Service Magazine**An Improved Oil Filler Cap is Available for Certain Caterpillar Machine Engines {1316}****Media Number -M0099385-04****Publication Date -2019/12/17****Date Updated -2019/12/17**

An Improved Oil Filler Cap is Available for Certain Caterpillar Machine Engines {1316}

Illustration 1

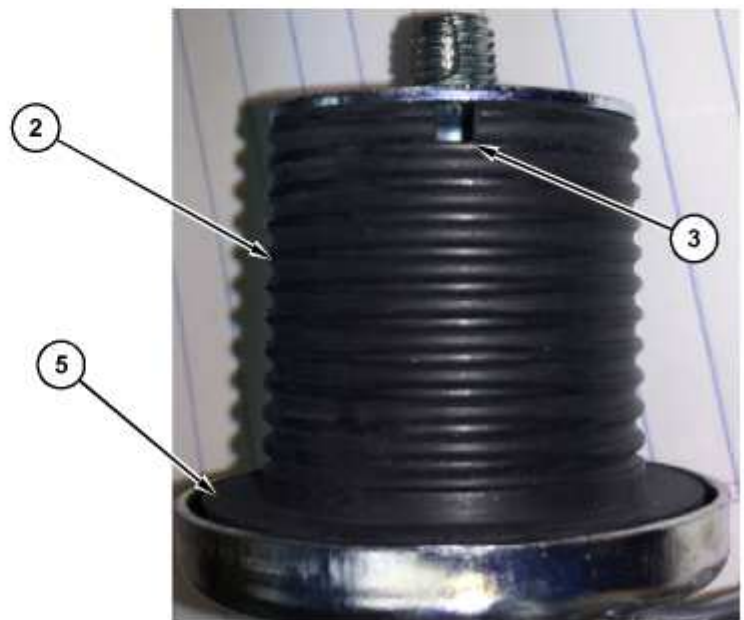
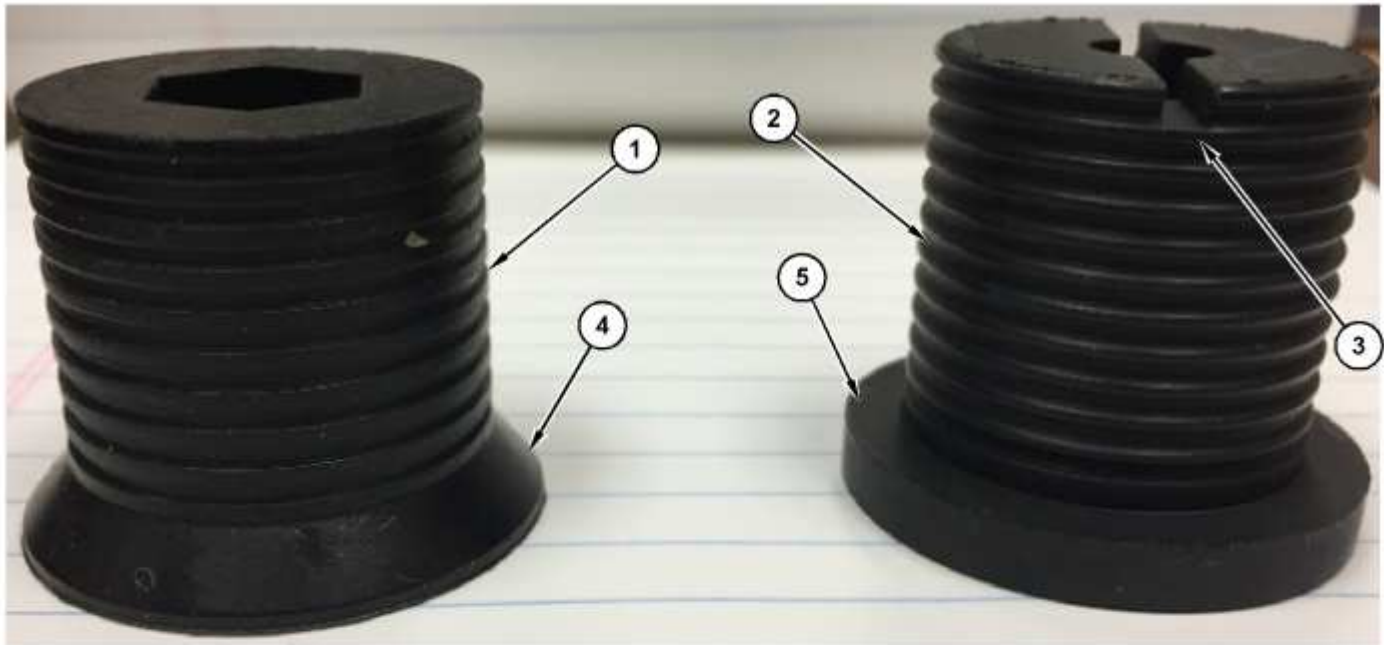
Description Of Change: The improved oil filler cap offers an improved rubber plug design.

The improved part can be identified by observing the rubber plug.

The former part has a slot at the base. The improved part does not.

The former part is flat at the cap end. The improved part is tapered.

Order the current part numbers **260-4810** Engine Oil Filler Cap As and **068-4497** Oil Filler Cap As to receive the improved part.
